Subject: Negative Declaration for Kane'ohe Stream Maintenance Dredging Project,
Tax Map Key: 4-5-30: 40 and 47, Kaneohe, Oahu, Hawaii

Kaneohe Stream Maintenance Dredging Project

Environmental Assessment Kane`ohe Stream Maintenance Dredging Project

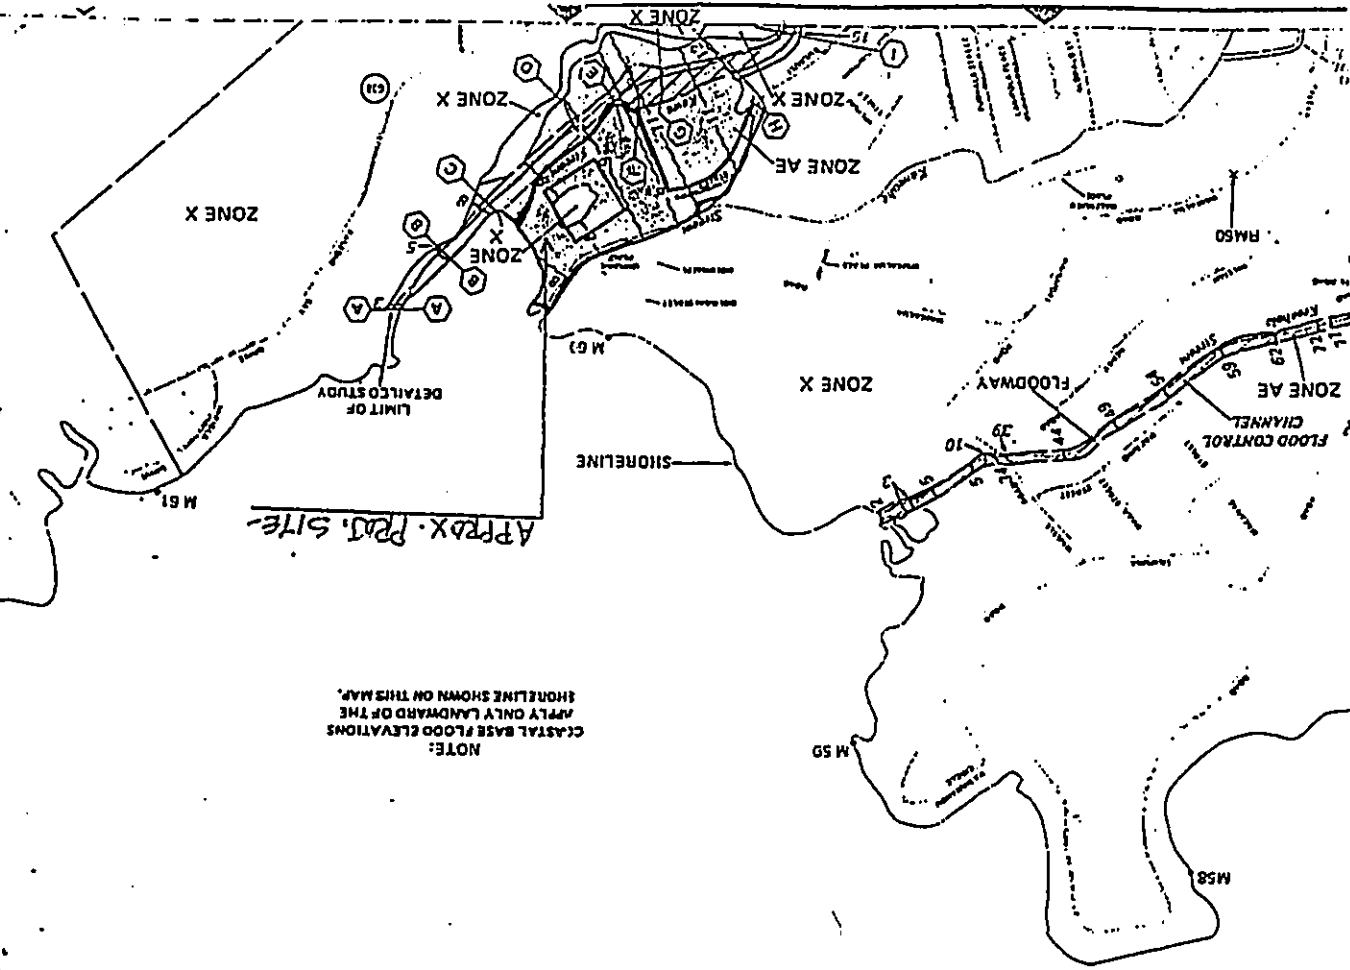
c. According to the enclosed Federal Emergency Management Agency's Flood Insurance Rate Map, panel number 150001 00608 dated September 4, 1987, the project site is located in Zone AE (special flood hazard area inundated by the 100-year flood with base flood elevations of 8 to 12 feet above mean sea level). Should you require additional information regarding this evaluation, please contact Ms. Jessie Dobinchick of my planning staff at 438-7008.

Response: The DPW is aware of the base flood elevations in the project area as shown on the Flood Insurance Rate Map and these will be noted in the final Environmental Assessment.

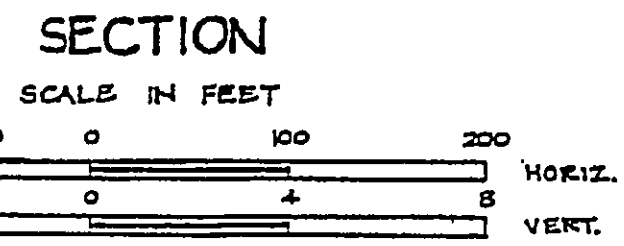
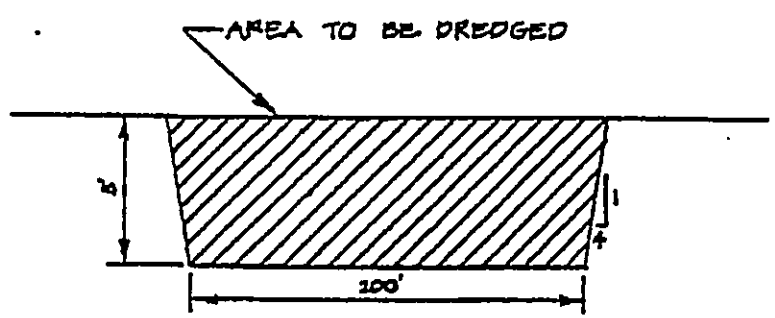
Comment: The proposed project appears to deviate in extent from the map shown in the U.S. Army Corps of Engineers existing General Permit.

b. Corps authorization for maintenance clearing of Kaneohe Stream under PODCO GP82-1E-B is limited to maintenance of about 200 feet near the stream mouth and removal of about 4,700 cubic yards of material. The project described in the environmental assessment is for removal of about 20,000 cubic yards of material from a 1,300-foot reach. As stated in the May 29, 1992 General Permit authorization letter, deviations in the scope or limits of the work must be reported for necessary modification of the authorization. The Department of Public Works will need to notify our Operations Division directly regarding the changes as well as the plans for

Response: According to discussions with Corps officials, the proposed work is within the bounds of the existing permit.

We have discussed the extent of coverage of the General Permit 82-1E-B with the COE. The map included the present General Permit applied to the proposed maintenance work under an earlier version (March 12, 1992) of the General Permit. In the current General Permit Notice of Authorization (May 29, 1992) from the COE to the Department of Public Works, Mr. Michael T. Lee, Chief, Operations Branch notes that, "Should there be any deviations from the locations, scope and limits of work as shown in the attached drawings, you should notify our office for necessary modification of this authorization."
